SYDNEY WEST CENTRAL PLANNING PANEL

COUNCIL ASSESSMENT REPORT

Panel Reference	2015SYW171_DA
DA Number	DA/709/2015
LGA	City of Parramatta
Proposed Development	Staged development comprising lot consolidation, demolition of existing structures, tree removal, site remediation, excavation of 4 storey basement providing 255 car parking spaces and construction of a 20 storey mixed use building comprising 5 retail tenancies and 264 residential units, landscaping and construction of a public vehicular lane in 2 stages (The application is Nominated Integrated Development for the purposes of the Water Management Act 2000)
Street Address	2 – 6 Cowper Street & 5 East Street, Granville NSW 2142 (Lot 2 DP 998932, Lot 1 DP 559802, Lot 2 DP 558199, Lot 1 DP 786191)
Applicant/Owner	R S Dpg Project 11 Pty Ltd / A A Abba Spray (Properties) Pty Ltd
Date of DA lodgement	2 October 2015
Number of Submissions	None
Recommendation	Deferred Commencement Consent
Regional Development Criteria (Schedule 4A of the EP&A Act)	Pursuant to Clause 3 of Schedule 4A of the Environmental Planning and Assessment Act 1979, the development has a capital investment value of more than \$20 million.

Report date	13 April 2017

Figure 7. Revised ground floor plan showing proposed laneway.

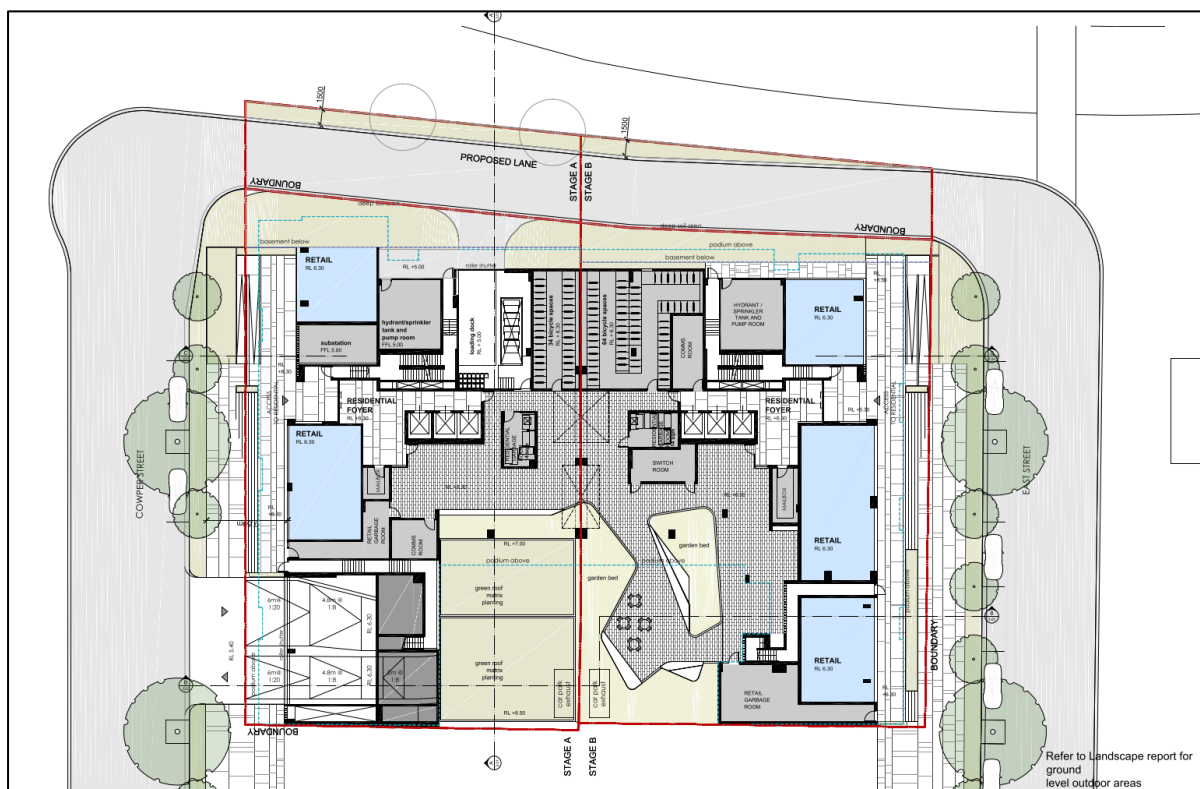
The proposal includes dedication of a publicly accessible vehicular laneway to the east of the site as required by PDCP 2011. The proposal, in conjunction with a concurrent proposal under assessment within the same block bound by Cowper Street, Rowell Street and East Street (DA/961/2015) will provide block-wide public domain upgrades including new kerb and guttering, stormwater infrastructure, electrical wire undergrounding and planting.

4.1.6 Granville Town Centre		
Pedestrian Connections and Laneways Map outlines north-south laneway required on eastern side of site.	<p>The proposal includes provision and dedication of a new laneway on the eastern side of the site connecting East Street and Cowper Street. The laneway would provide the public benefit of improving through block connections, reducing traffic congestion, remove dead end streets and providing public views of the creek.</p> <p>Where a lane is provided a variation to Council's floor space ratio control can be sought under Section 4.1 P.1 of the DCP. The proposal includes dedication of 499m² as a public lane. As such an additional 249.5m² of gross floor space can be accommodated on site.</p>	Yes
C.1 Front Setbacks 3m (up to 4 storeys) 6m above 4 storeys	<p>East Street: 2.0m – 3.0m Cowper Street: 1.2m</p> <p>East Street: 4.9m – 6.2m Cowper Street: 3.8m – 4.8m</p> <p>While the proposal would be mostly non-compliant with the required setbacks the application also includes</p>	Partial

Figure 9. Revised east-west section showing breach of building height (blue line represents 52m height standard).

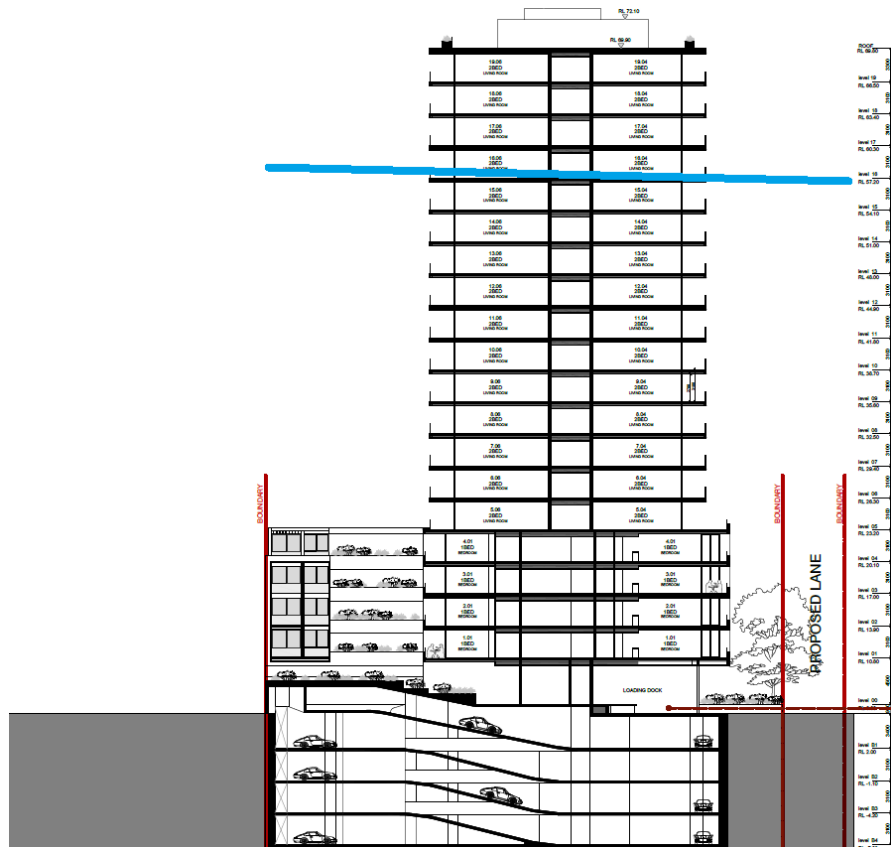
The proposed building generally follows the form for the site envisaged by Parramatta LEP 2011 and Parramatta DCP 2011 except for a significant exceedance of the maximum height development standard. The applicant has submitted a request to vary the height development standard under clause 4.6 of PLEP 2011. The request is considered to be well founded for reasons including, but not limited to the scale of surrounding development, the separation from adjoining developable land to the east, public domain improvements, site constraints, and design excellence.

- Increase in building height to 67.7m, variation of 30.2% to permitted maximum building height of 52m (previous building height was 64.5m representing a variation of 24%).
- Roof top terrace has been provided for additional communal open space.
- Increase in retail/commercial area to 335m² (previously 215m², 2 tenancies)
- Modifications to ground floor and public domain.
- Increased building separation and setbacks.
- Reconfiguration of apartment mix and internal layouts.
- Deep soil now provided on development site.
- Basement Level 5 has been deleted.
